Attachment E

Re: Comments on Gulf Power's Ten-Year Plan Submittal

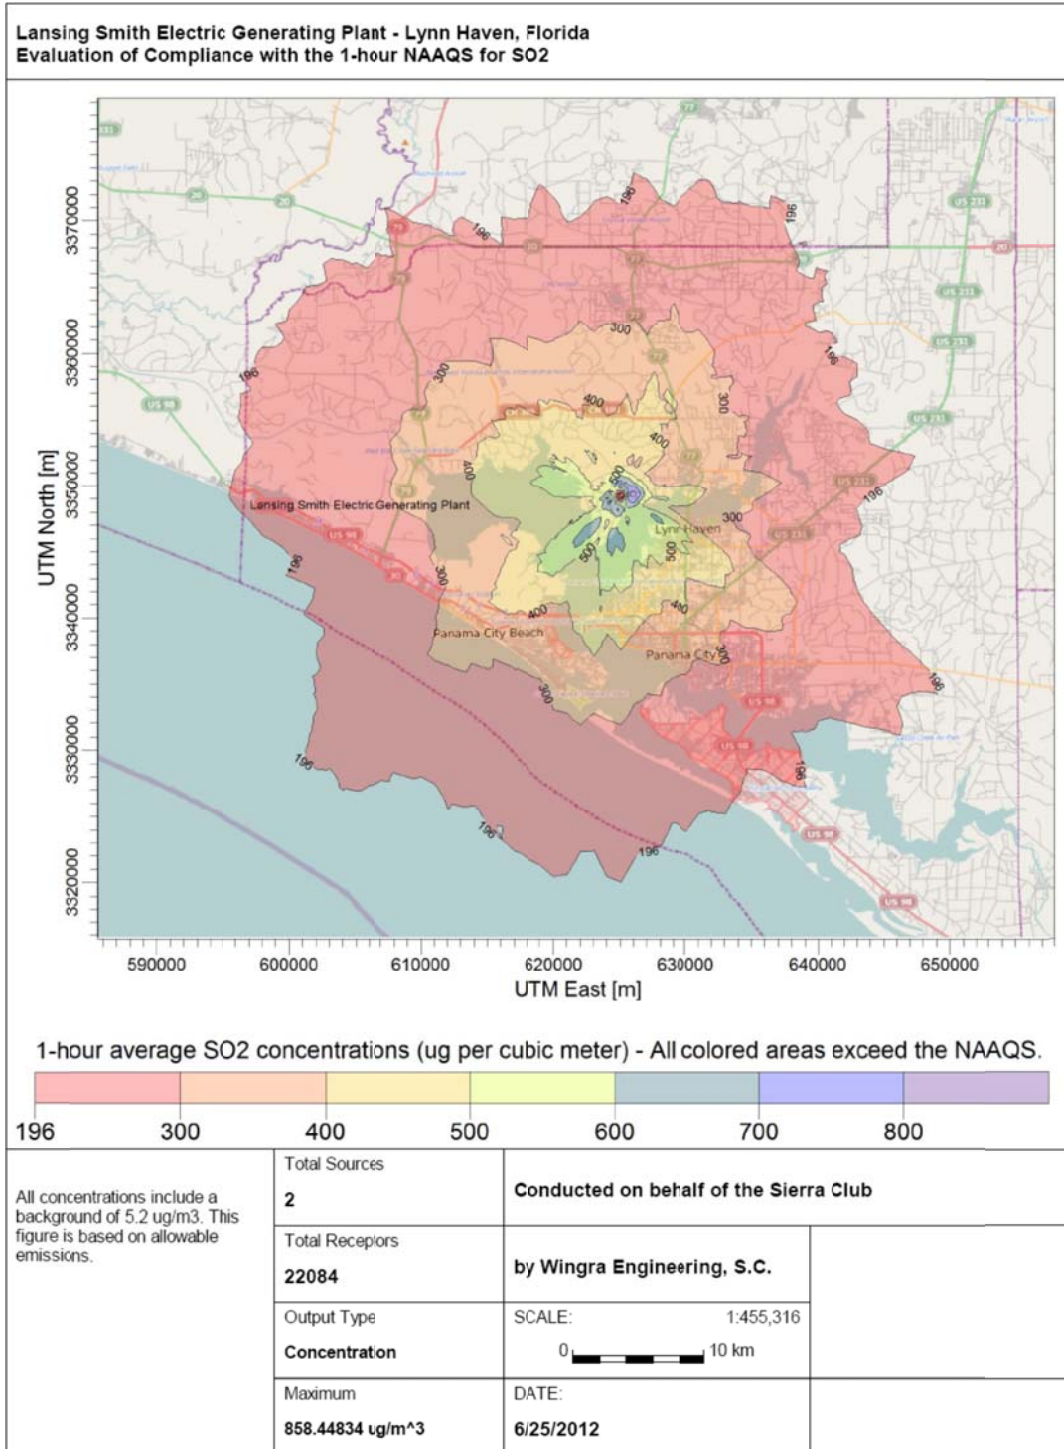
The figure below shows the SO₂ pollution plume the plant would create when operating at its permit limits. All colored areas violate the NAAQS. While the NAAQS is set at 196.2 µg/m³, Lansing Smith's permit allows pollution levels to soar to 858.4 µg/m³, over 400% of the safe value; even a bit further away from the plant, pollution directly over downtown Panama City reaches levels close to double the safe value.

Importantly, Lansing Smith causes NAAQS violations even when operating below its permitted maximums. Last year, Lansing Smith's highest operating hour emissions saw SO₂ concentrations reach 346.5 µg/m³, which is nearly double the safe value. See Ex. 2 at Table 1.

To reduce this illegal pollution, Lansing Smith would have to cut total facility emissions by 77.6% from its current permit. *Id.* at Table 3. To do so, it is highly likely to have to install a scrubber, thereby confronting hundreds of millions in control costs, which we document more fully below. Importantly, these costs will be far outweighed by public health benefits. EPA determined that the NAAQS will produce on the order of \$36 billion in *net* benefits once safe levels of SO₂ have been attained. 75 Fed. Reg. at 35,588. Panama City residents will secure a substantial portion of these benefits – in the form of fewer asthma attacks, emergency room visits, and premature deaths – once Lansing Smith's pollution has been controlled.

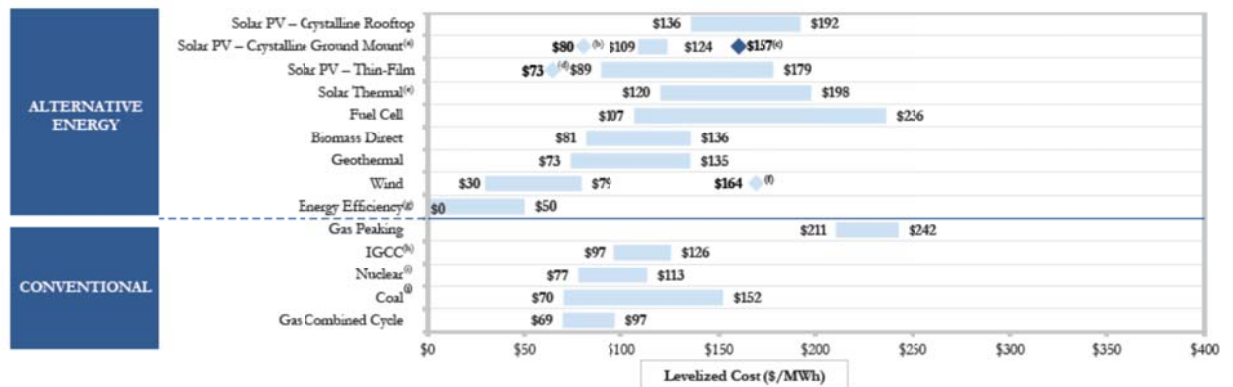
Industry-wide levelized cost figures compiled by independent analysts demonstrate why these retirements are occurring. The most recent (2011) edition of Lazard’s Levelized Cost of Energy Analysis,¹¹ a widely-used reference, shows that energy efficiency, wind, and natural gas combined cycle levelized costs are already below those of coal, as the figure below demonstrates.
